**EASTERN TECHNOLOGIES, INC. LETTER DATED MAY 26, 2005 CONTAINING
ADDITIONAL INFORMATION FOR LICENSE AMENDMENT REQUEST
(NRC License No. 01-30362-01; Docket No. 030-36499)**

SUBJECT: License Number 01-30362-01 03036499

Enclosed are the updated drawings that are applicable to EIT's facility that we propose to locate at 3114 Point Township Drive, Northumberland, Pennsylvania 17857. The request to change our current license's address to this new location was submitted in an earlier correspondence.

PROJECT		Pennsylvania Facility	
TITLE		Dryer Exhaust and HEPA Filtration	
NO.	DATE	NO.	PP004
DATE	09/00	NUMBER	1 of 1

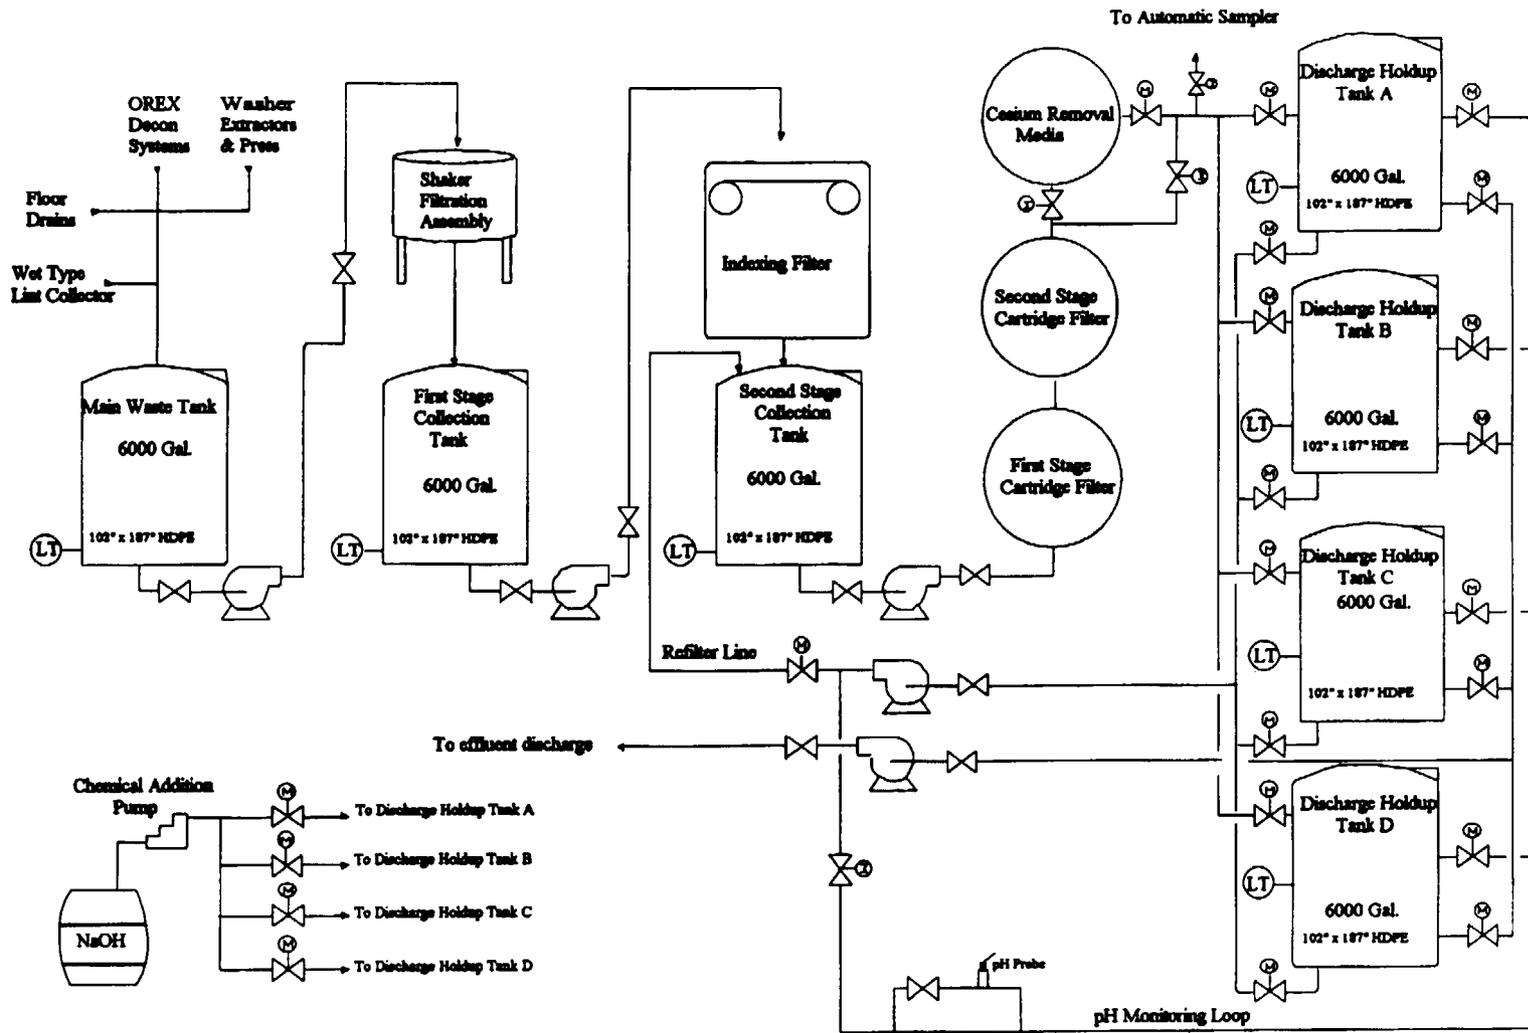
One other change that ETI has made note of in the plans is the possibility of using a dry type lint collector to accumulate lint and debris exiting the dryers prior to it reaching the pre-filtration section of the Dryer Exhaust HEPA Filtration System. The original submission detailed only the possibility of using a wet type lint collector for this activity. If used the dry type lint collector will operate much in the same way as the wet type lint collector except that it will use filtration screens to trap the larger lint particles as opposed to water. These screens are automatically cleaned by the lint collector and the accumulate debris deposited into a collection receptacle.
